Client	Mrs Husbands
Project Name	28 Tennyson Road, Woodley
Report Title	Transport Note
Report Ref.	TN01
Project No.	C25179
Date	06/10/2025
Produced By:	LK / DC

1. INTRODUCTION

2. LOCAL HIGHWAY AUTHORITY COMMENTS

Figure 2-2: PIA study area and recorded data

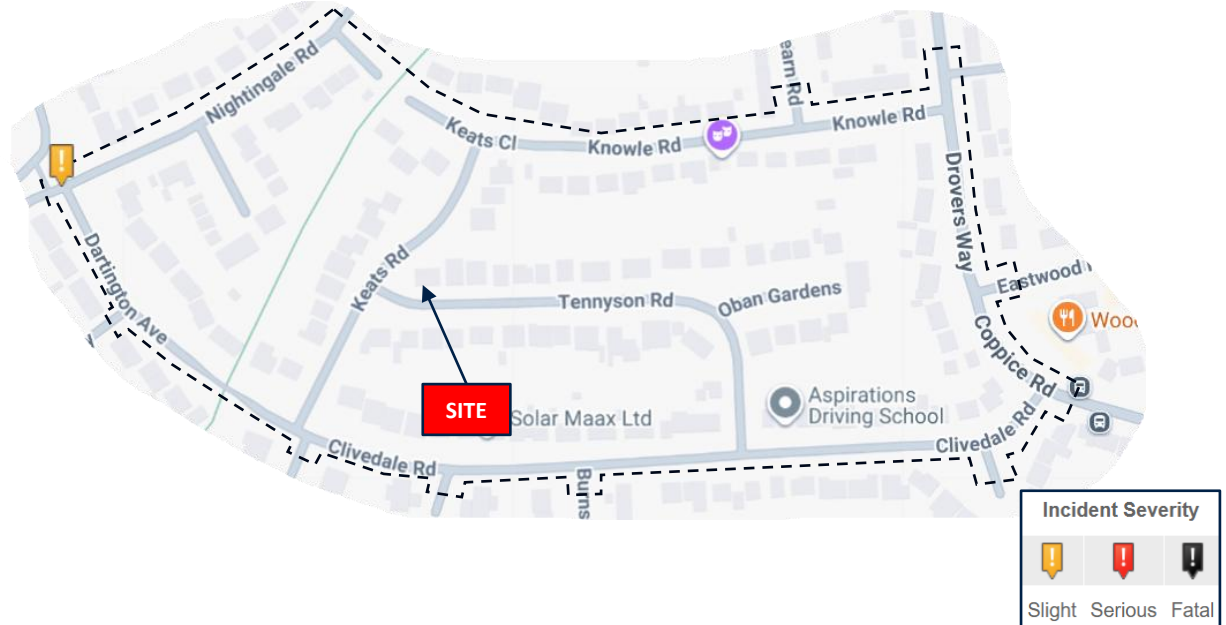
"Keats Road and Tennyson Road are subject to speed limits of 30mph. The applicant has demonstrated 21m forward visibility for vehicles travelling along Keats Road turning onto Tennyson Road, which is commensurate with a speed of 17.4mph. While the Highways agree that the acute bend will reduce the travelling speed of vehicles, the applicant will have to justify 21m forward visibility is sufficient with speed survey data."

- 2.1.10 Finally, existing road safety conditions have been considered. Personal Injury Accident (PIA) data has been obtained from road safety data published annually by the Department for Transport (DfT). The statistics provide PIA data which has been recorded using the STATS19 accident reporting form. This review covers the four-year period prior to the pandemic between 1st January 2017 and 31st December 2019, data from the two years during the pandemic between 1st January 2020 and 31st

- 2.1.11 The study area includes Tennyson Road, Keats Road, Keats Close, Knowle Road, Drovers Way, Coppice Road, Clivedale Road, Oban Gardens, Dartington Avenue and Nightingale Road as shown at Figure 2-2.

- 2.1.12 The data shows that within a wide study area, a single slight injury accident occurred within the most recent seven year period. No serious or fatal accidents occurred during this time.

- 2.1.13 The single PIA involving two cars and occurred at the junction of Dartington Avenue and Nightingale Road. This single occurrence does not indicate a recurring issue locally.

Appendix B Visibility Splays Surrounding the Site

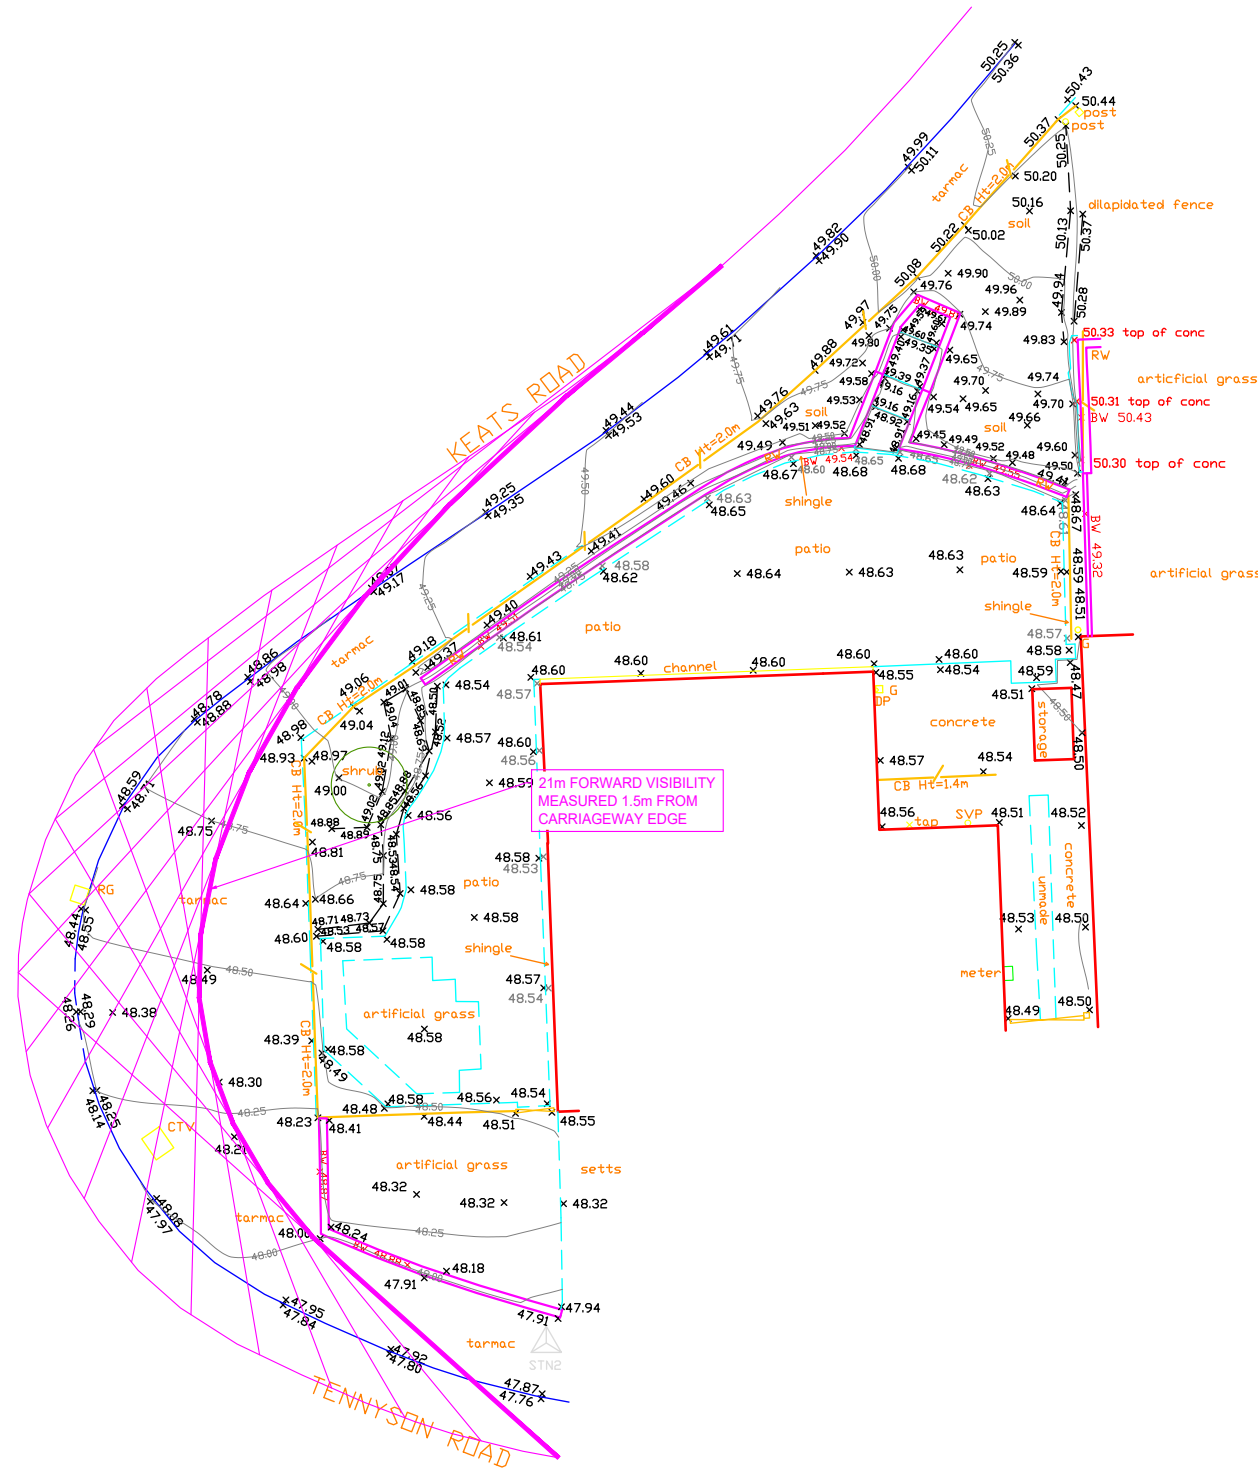
“Meanwhile, the applicant is required to justify sufficient visibility can be achieved from minor arm (Tennyson Road turning onto Keats Road) and driveway of 4 Keats Road and 26 Tennyson Road to justify there will be no detrimental impact to the neighbouring site.”

- 2.1.20 There is no requirement for the applicant to demonstrate or justify the existing visibility at the priority junction of Tennyson Road and Keats Road.

- 2.1.21 The proposed/realigned fence, which is erected within the applicant’s land is not on the public highway and therefore, does not obstruct existing vehicular visibility at the junction. The junction is provided with appropriate levels of visibility, within the existing extent of public highway.

- 2.1.22 There is also no requirement to demonstrate any impact upon property no. 4 Keats Road, to the north of the site and property no. 26 Tennyson Road, immediately east, simply as the new fence/wall at no. 28 Tennyson Road is delivered within the applicant’s land and would have no impact on their visibility.

- 2.1.23 In addition to this, the fence would have no impact on the visibility from 26 Tennyson Road or 4 Keats Road as it is not in the visibility splays of either of these properties. The visibility from 26 Tennyson Road is approximately just 16m to the west, as the constraint point is the existing boundary of 28 Tennyson Road, which is not changing as a result of this proposal. The visibility along Keats Road from 4 Keats Road is unchanged with the new fence, as it can achieve 43m to the carriageway edge and this runs along the footway.

2.1.24 The visibility from the junction of Tennyson Road is unaffected, as a distance in excess of 43m can be obtained to the north within the footway and carriageway, due to the alignment of Keats Road at this point.

2.1.25 These visibility splays are shown in a drawing in Appendix B.
